PRELIMINARY OVERALL
AREA DEVELOPMENT PLAN
LINCOLN PARK SUBD. - UNIT I
SAN ANTONIO TEXAS

PRELIMINARY OVERALL
AREA DEVELOPMENT PLAN
LINCOLN PARK SUBD. - UNIT 2
SAN ANTONIO
TEXAS

INFORMATION SHEET FOR
PRELIMINARY OVERALL AREA DEVELOPMENT PLAN
(P.O.A.D.P.)

Re: Subdivision U-1&2 ☐ Preliminary Plan
☒ P.O.A.D.P.

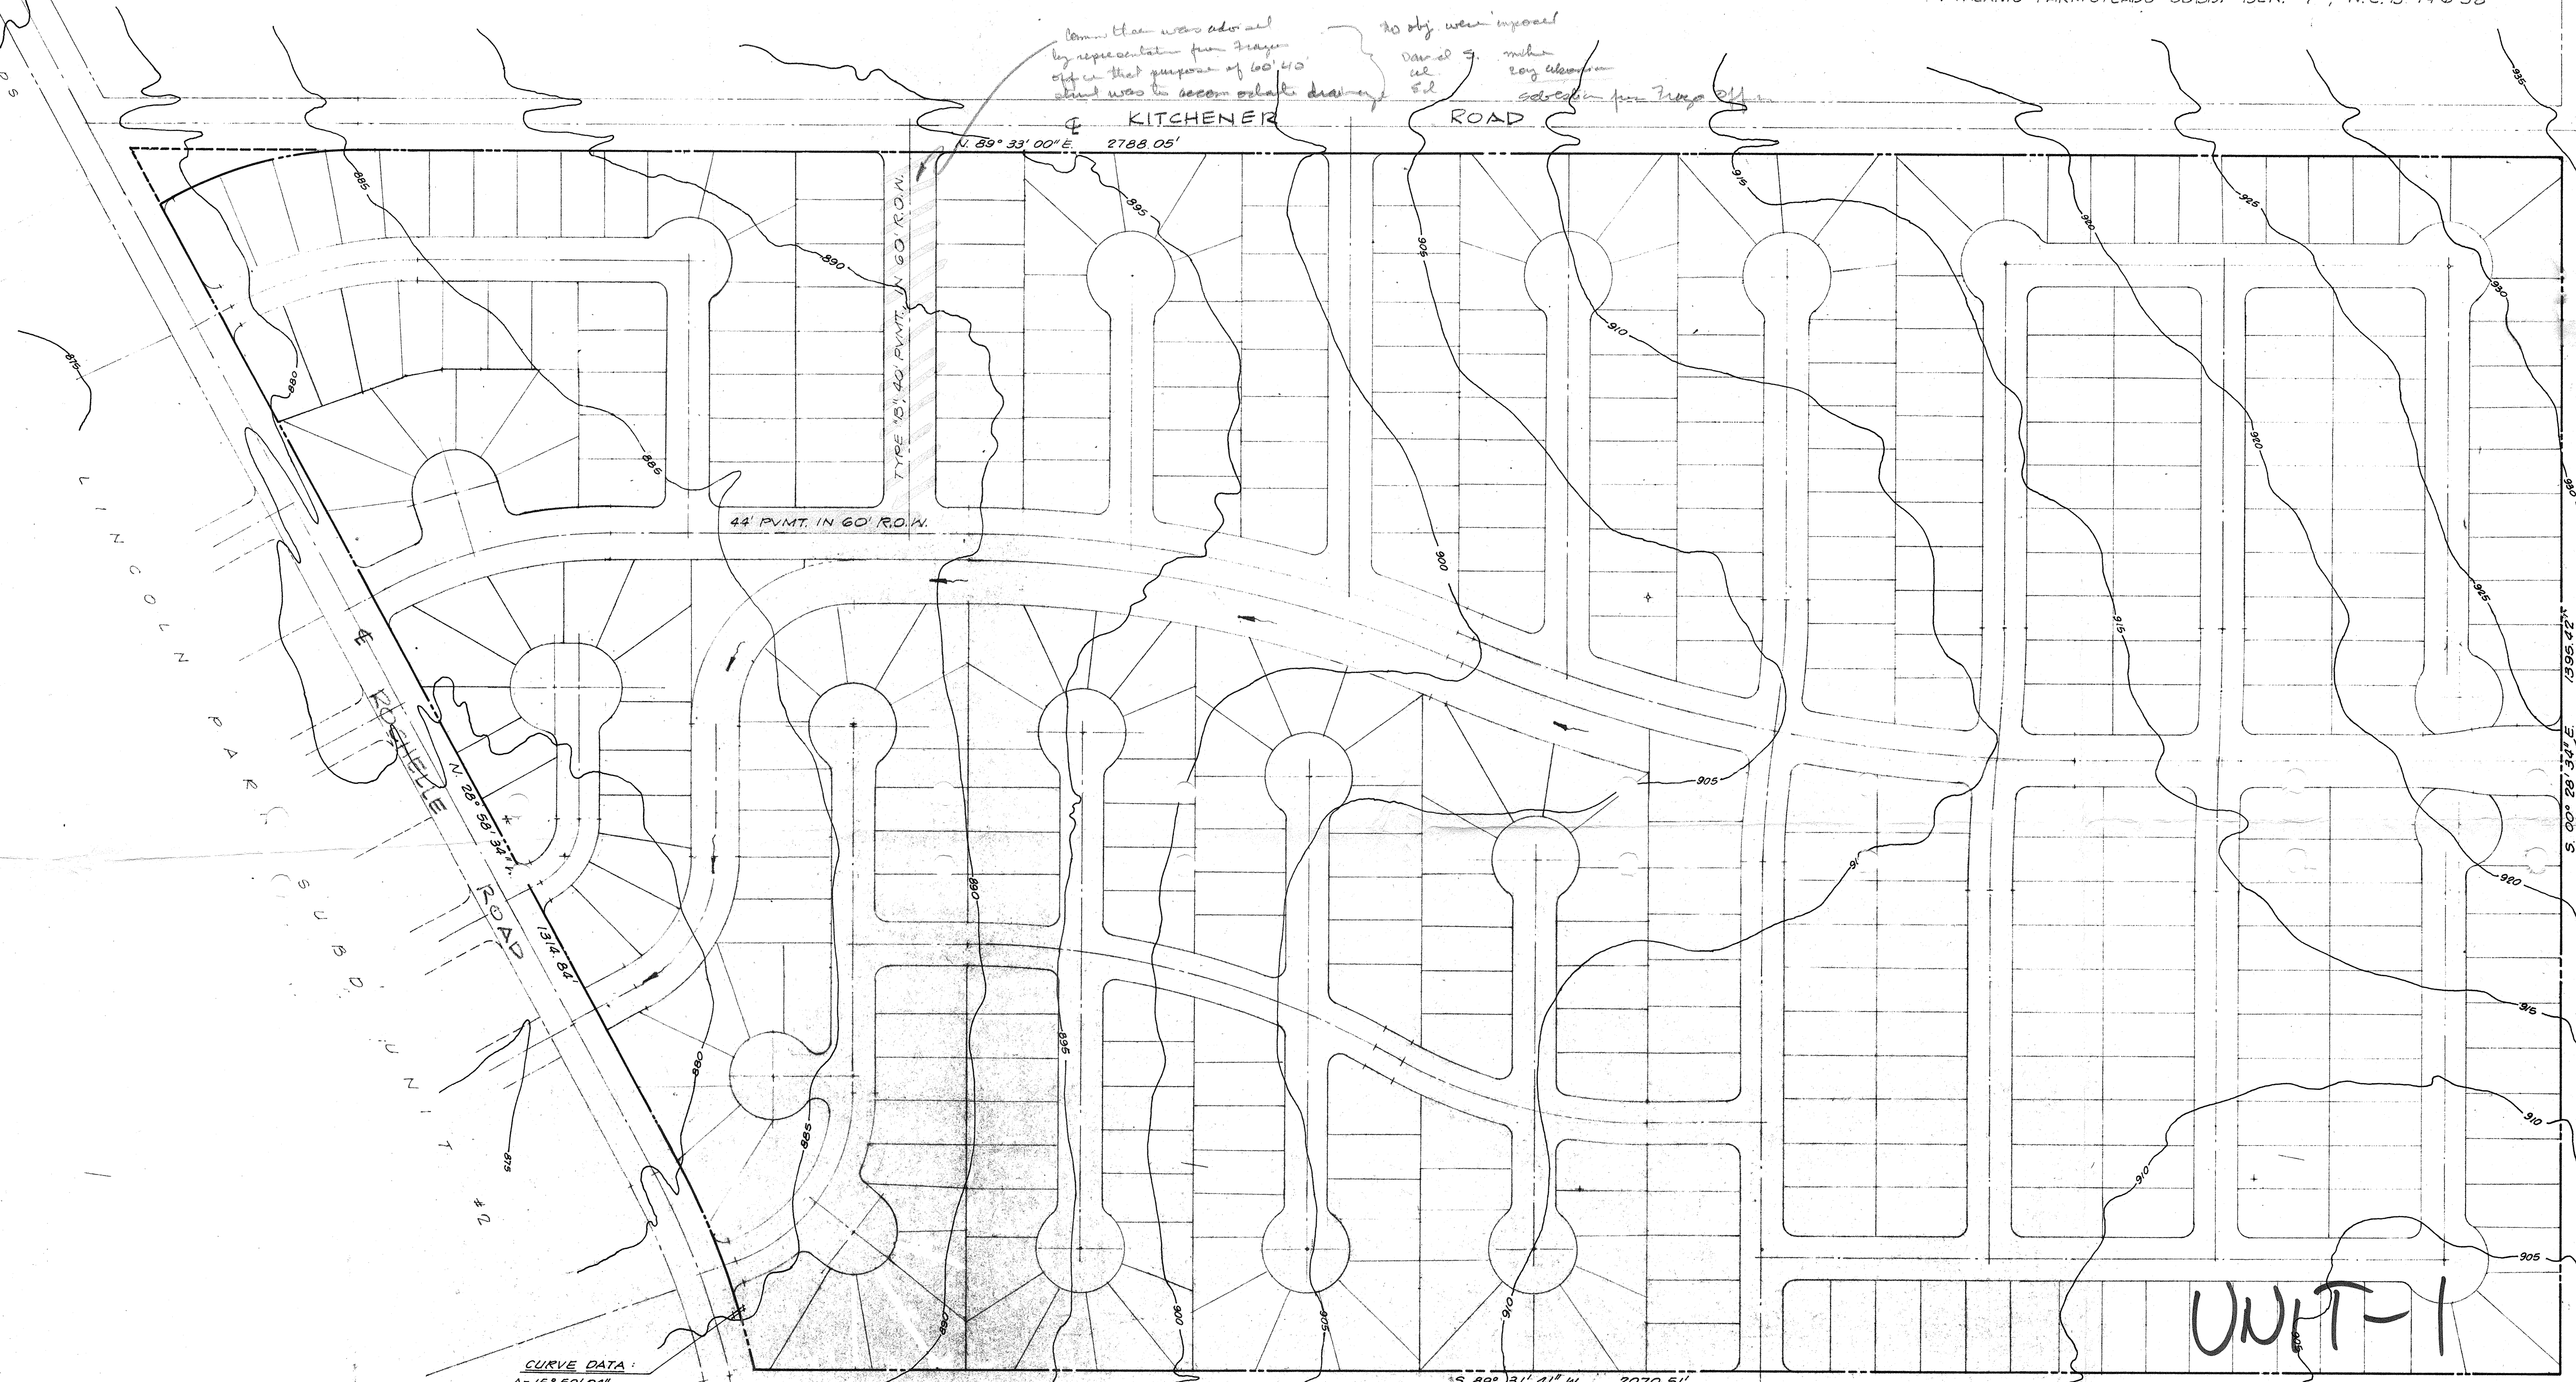
3-14-84
Spoke to Dan review is flooding subd. design for the
area west of Rochelle Rd.

Committee felt there was a need to invite Mr. Frazor to make staff
in order to discuss the planned proposal.

issue addressed were:

- (1) plans for street connection to accommodate driveway
- (2) traffic volumes generated by this devel.
- (3) proposal to reduce paving width for street planned as local "B" or

Spoke to Dan advised him that since the area west was to be developed in conjunction with this proposal the ~~overall~~ overall planned development needs to be considered. Dan will submit Unit #2 so to review both units at the same time.
